CITY OF ALBUQUERQUE

**RE: Broadstone Highlands Hotel Block
Grading and Drainage Plan
Engineer's Stamp Date: 5/4/18
Hydrology File: K15D034B**

Based on the information provided in the submittal received on 5/4/18 the above-referenced Grading and Drainage Plan cannot be approved for Building Permit until the following are addressed:

OVERALL GRADING &
DRAINAGE PLAN

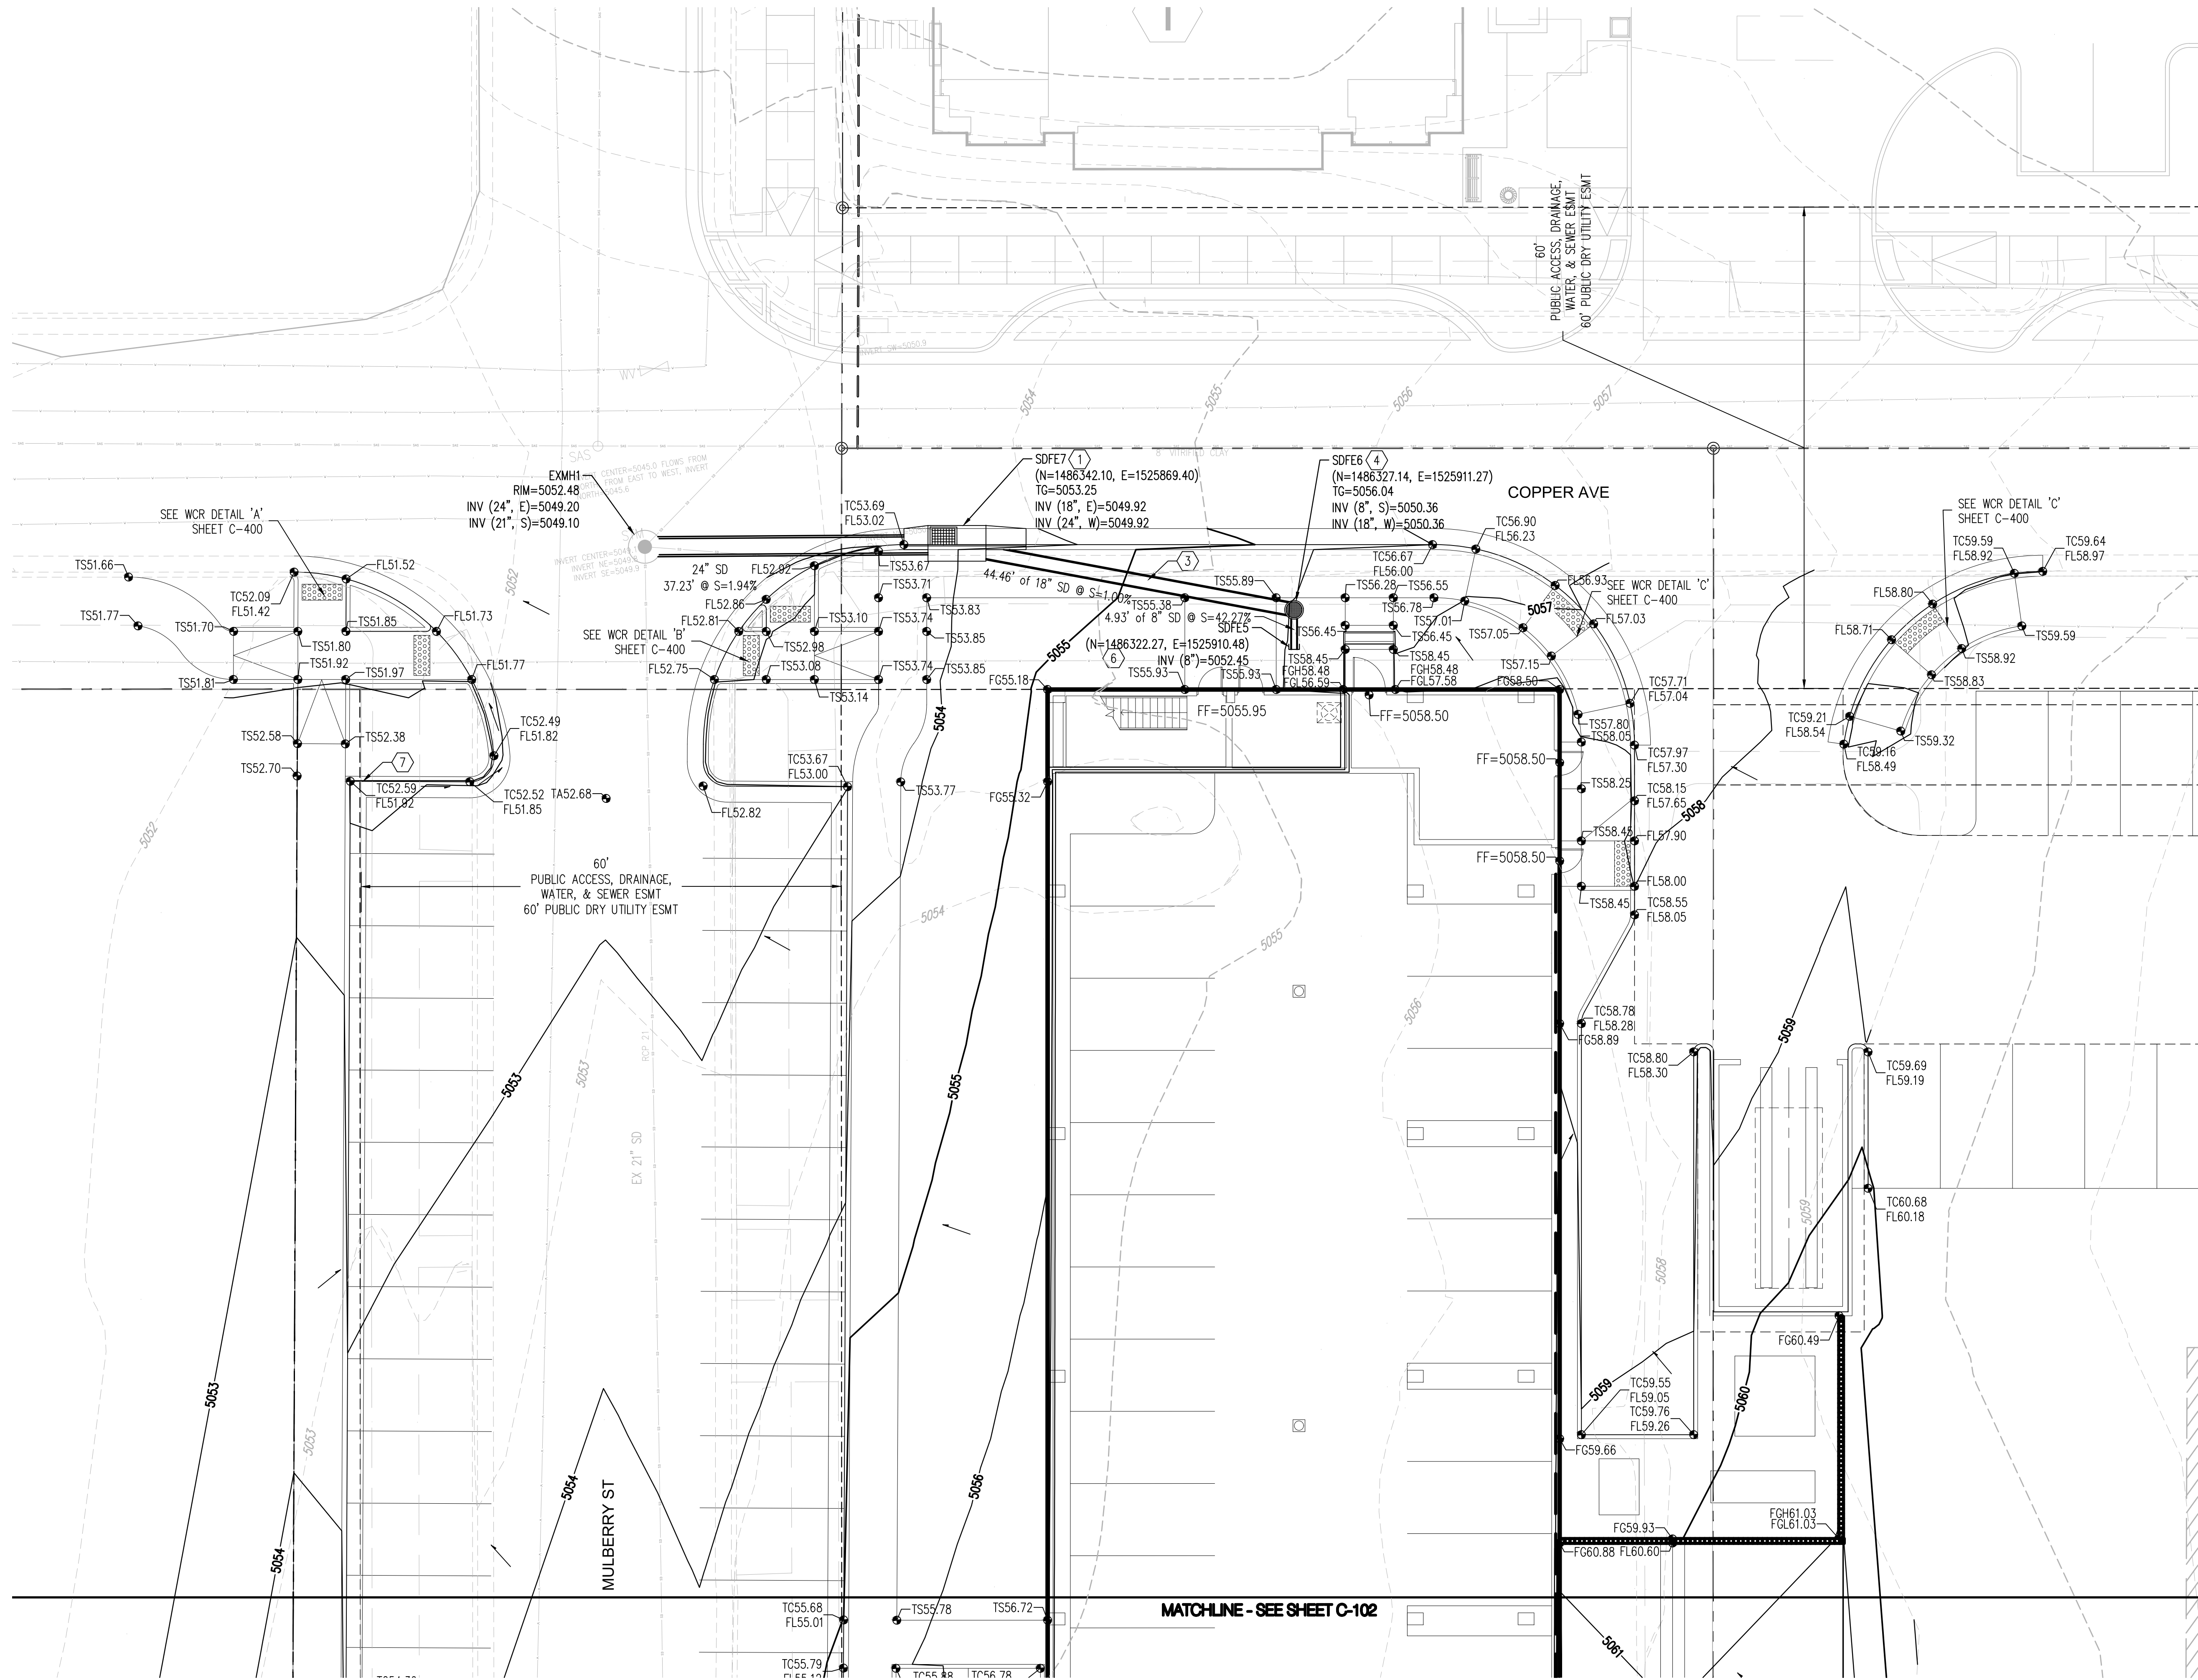
1. Clearly define which elements of the grading plan and drainage improvements are public and to be constructed by work order, and which elements are private and to be constructed by building permit.

2. Add note on the plan that "No work shall be performed in the public ROW and public easements without an approved Work Order."
3. The 18" HDPE penetration into the new (public?) type-A inlet cannot be accepted. This will either need to be RCP, or be 12" or less and piped into back on inlet, similar to std dwg 2237.

4. Provide valley gutter across the drive entrance on Copper and across the intersection of Copper and Mulberry.
5. Provide alley gutter along Mulberry, between the east parking and the drive aisle, where the drainage will concentrate.

6. Clarify how standing water will be prevented in the NW corners of the west parking along Mulberry. Curb cuts that allow water to drain across the sidewalk are not acceptable.

7. Provide sections of the proposed retaining walls/stem walls and show the property line, existing and proposed grades on the section views. In accordance with DPM Ch.22, section 5 part B, grading and wall construction near the property line may not endanger adjacent property or constrain its use.
